## Product Change Notice (PCN)

PCN Number: **PCN-0451143R-01**

Product(s) Affected: PJ-035DH

PREVIOUS CUI DEVICES DETAIL / IMAGE	NEW CUI DEVICES DETAIL / IMAGE

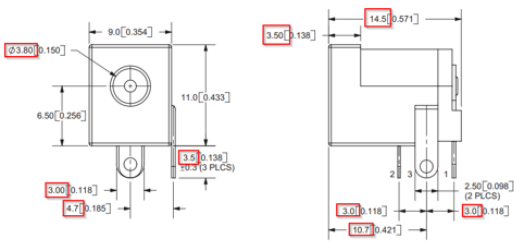
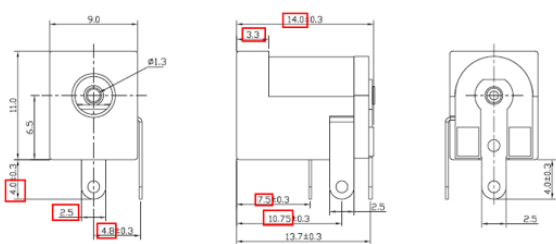
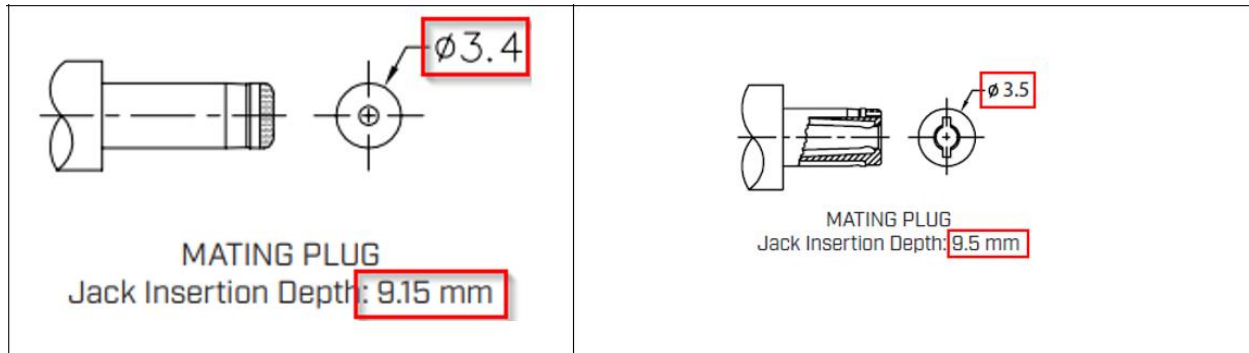
Description of Change: mechanical, and material differences as shown below:

MATERIAL	PLATING																																						
center pin	copper	nickel																																						
terminal 1	brass	silver																																						
terminal 2	copper alloy	silver																																						
terminal 3	brass	silver																																						
plastic	PBT																																							
DESCRIPTION	MATERIAL	PLATING/COLOR																																						
center pin	brass	nickel																																						
terminal 1	brass	silver																																						
terminal 2	bronze	silver																																						
terminal 3	brass	silver																																						
cover	PBT (UL94V-0)	black																																						
housing	PBT (UL94V-0)	black
